# 1997 - 2002 Corvette: Service Bulletin: Door Rattle with Moderate to High Audio System Volume

**Number:** 01-08-64-009A

**Date:** 06-19-2002

**Model Year:** 1997-2002 Chevrolet Corvette

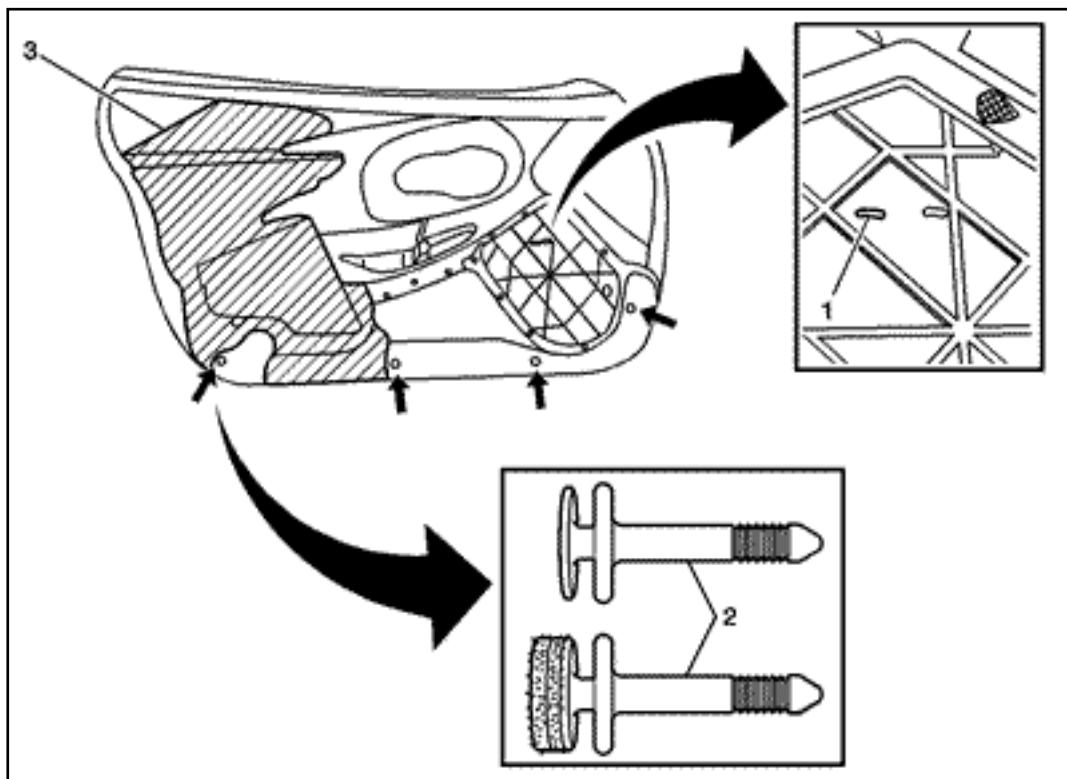
**Change implemented in 2002 VIN breakpoint 125078. Vehicles built prior to this breakpoint will require the following procedure.**

New speaker screen is made from a different material and Bose® emblem is provided due to risk of old emblem becoming damaged while removing.

1. Straighten the speaker grille tabs and remove the grille from the door panel.
2. Remove the Bose® emblem from the speaker grille and discard.
3. Remove the speaker screen from the grille and discard.
4. Install the new speaker screen to the grille.
5. Install the new Bose® emblem and carefully crimp the staples (1) to the speaker grille.
6. Insert the speaker grille tabs into the door panel slots and bend the tabs

to lock the grille in place.

7. Trim any extra loose door panel leather skin from around the speaker grille area on the back side of the door panel.
8. Repeat above steps for opposite side.

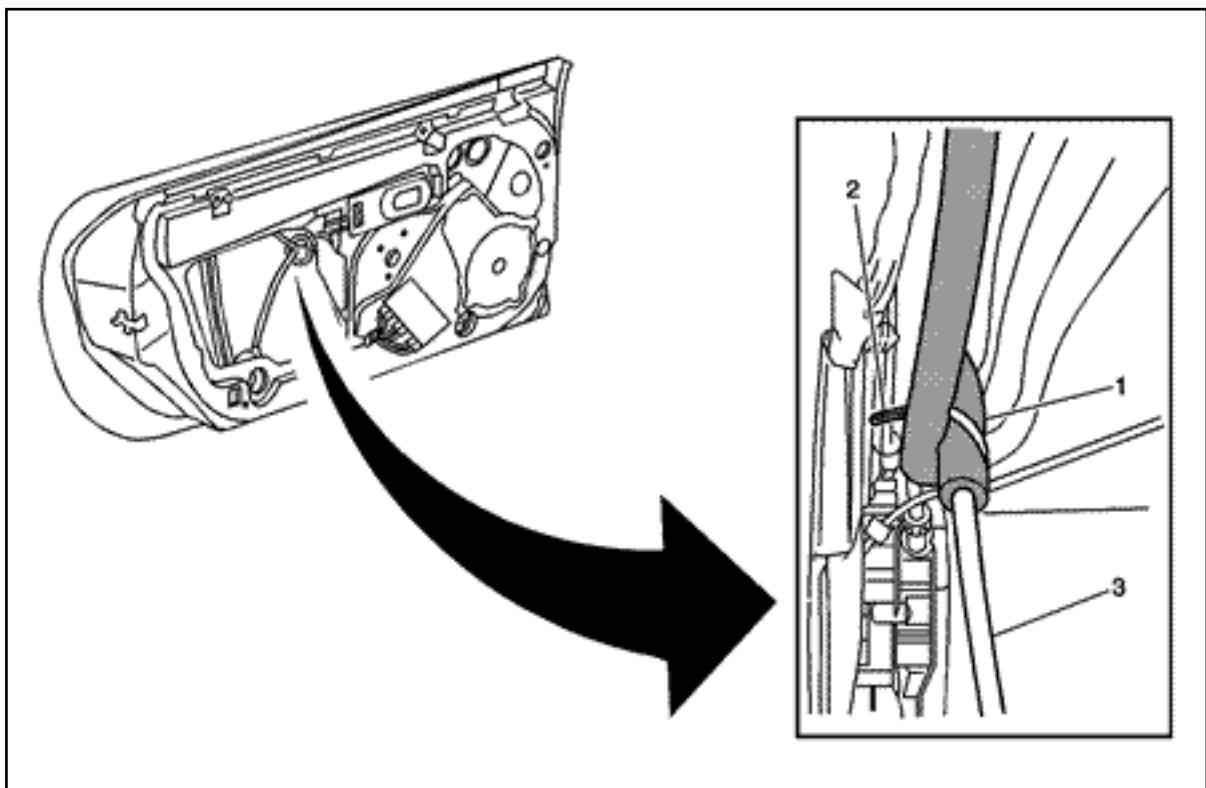
**Change implemented in 2001 VIN breakpoint 115500. Vehicles built prior to this breakpoint will require the following procedure.**

1. Remove the 4 lower door trim panel retainers (2) from both door panels.
2. Cut 16 dime sized coins from the fine side of Velcro®, 3M® P/N 051131-06481, or equivalent.
3. Install 2 Velcro® coins to each of the 8 door trim panel retainers (2).
4. Reinstall the door trim panel retainers (2) into the door trim panels.

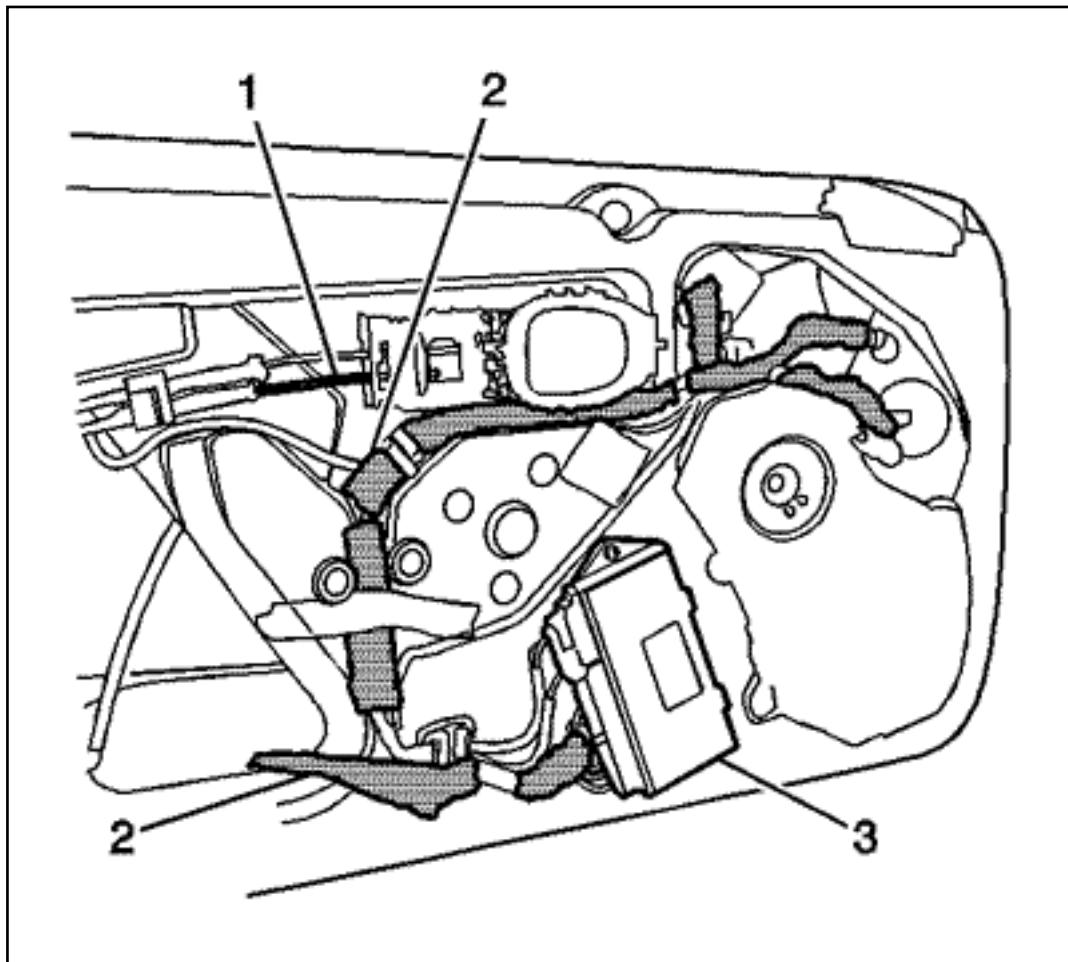
**Change implemented in 1999 VIN breakpoint 133100. Vehicles built prior to this breakpoint will require the following procedure.**

1. Remove the water deflector.

**Do not damage the push-in retainer/tie straps (2). They are to be reused.**

2. Remove the push-in retainer/tie straps (2) that retain the window regulator cables (3) to the inner door panels.
3. Reposition the push-in retainer/tie straps (2) out of the way.
4. Add 122 mm (5 in) of 3M® Open Cell Interior Foam Tape (1), P/N 051131-62385, or equivalent, to the window regulator cables (3) where they contact each other and the inner door panels.

5. Reinstall the push-in retainer/tie straps (2).
6. Reinstall the water deflector.

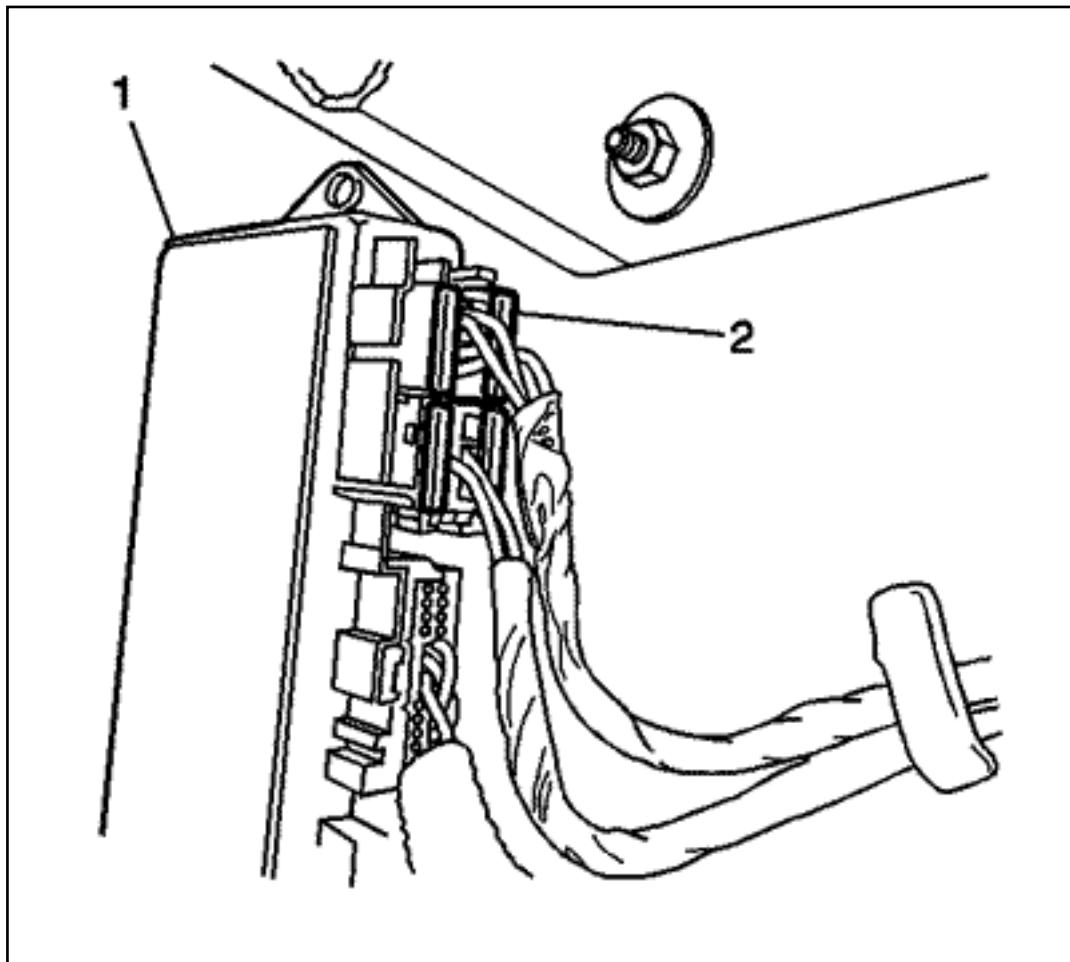
**Change implemented in 2000 VIN breakpoint 101578. Vehicles built prior to this breakpoint will require the following procedure.**

1. Remove the wire harness (2) from its retainers.
2. Insulate the wiring harness and in-line connectors (2) where the wiring harness and the in-line connectors (2) contact the door with 3M® Open Cell Interior Foam Tape (2), P/N 051131-62385, or equivalent. It is best to insulate the entire wiring harness (2).
3. Insulate the right door speaker connector with P/N 12378189.

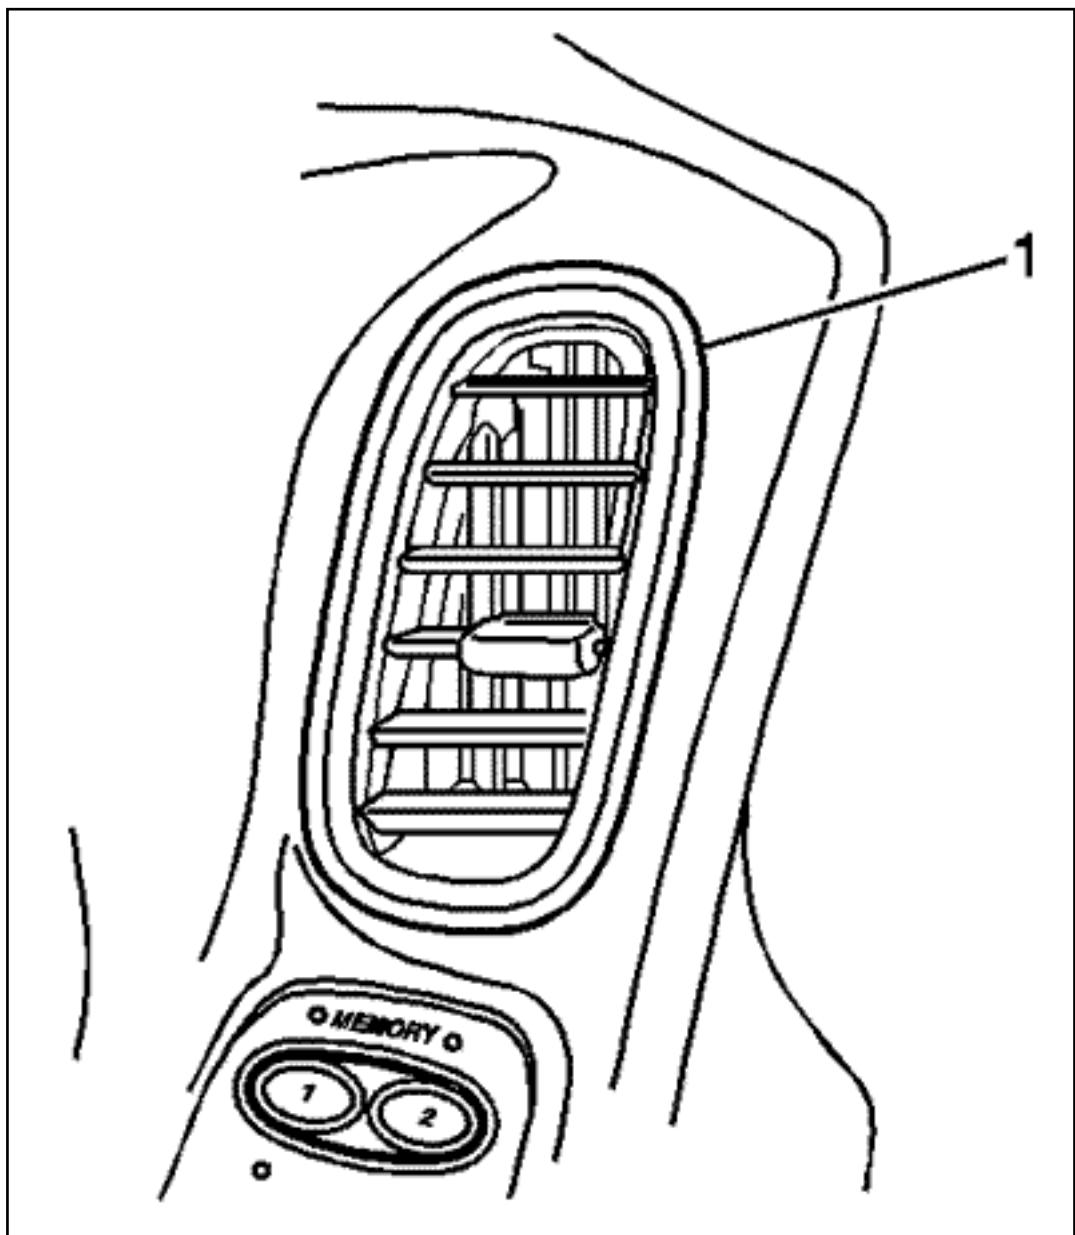
**Change implemented in 2000 VIN breakpoint 120397. Vehicles built prior to this breakpoint will require the following procedure.**

Add a small piece of duct tape, 3M® P/N 051131-06969, or equivalent, to the door control modules (1) terminal positive assurance (TPA)'s (2). They are grey in color and there are a total of 4 TPA's (2) per door. If the TPA's (2) are blue, they are the new design and do not need to be taped.

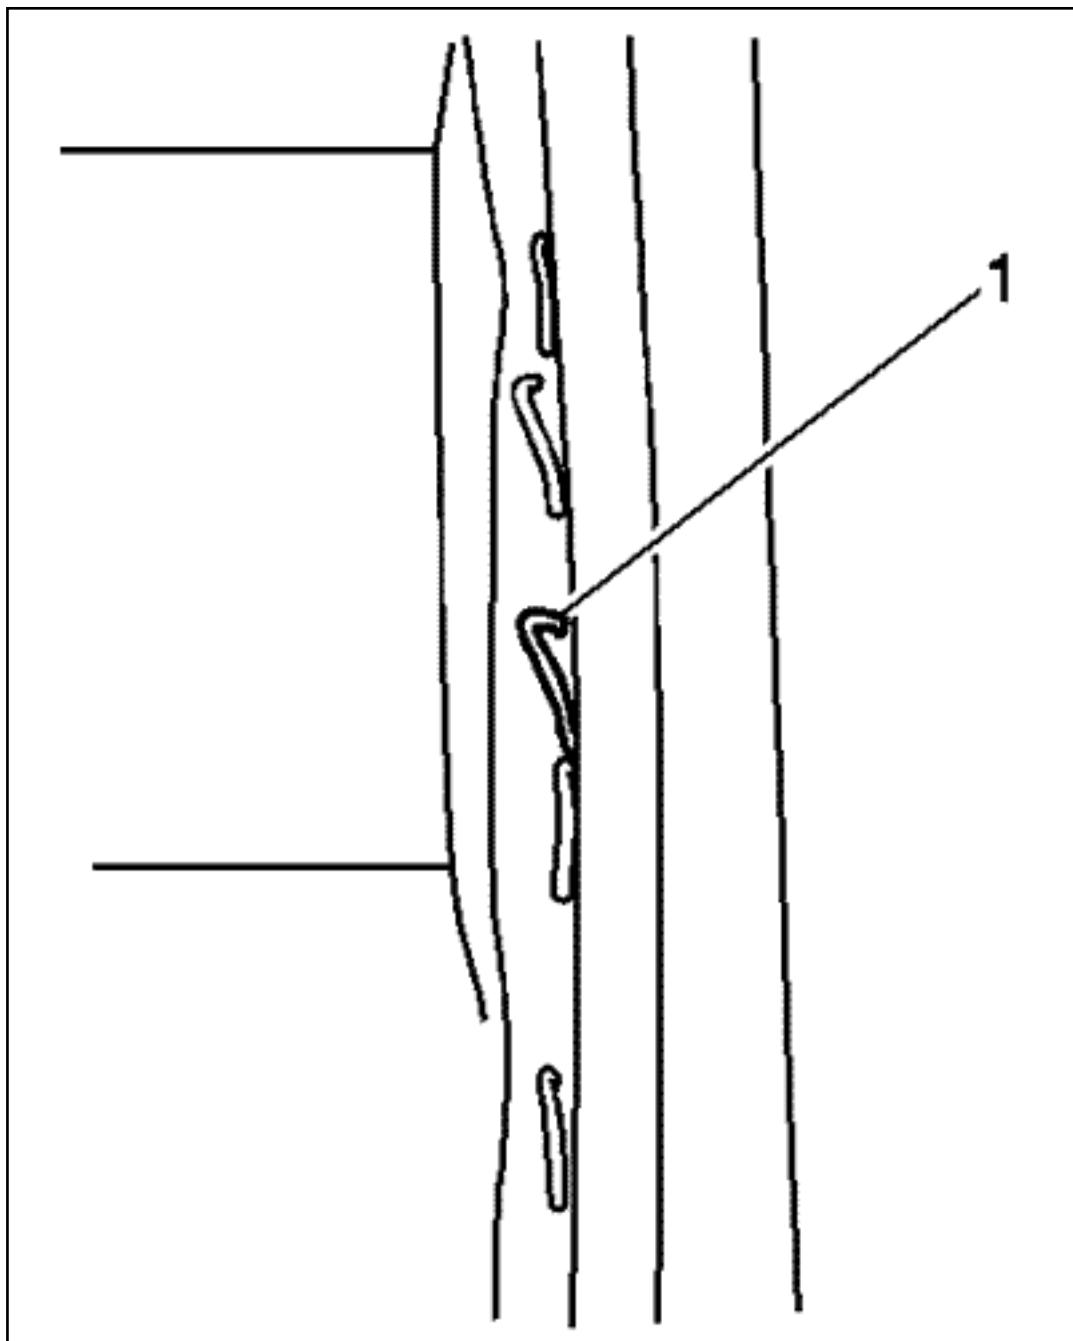
Replace the driver's door HVAC deflector (1), P/N 10406518, if the vanes of the deflector (1) are loose and vibrate. Refer to Door Trim Panel Air Duct and Deflector Replacement in the Service Manual.
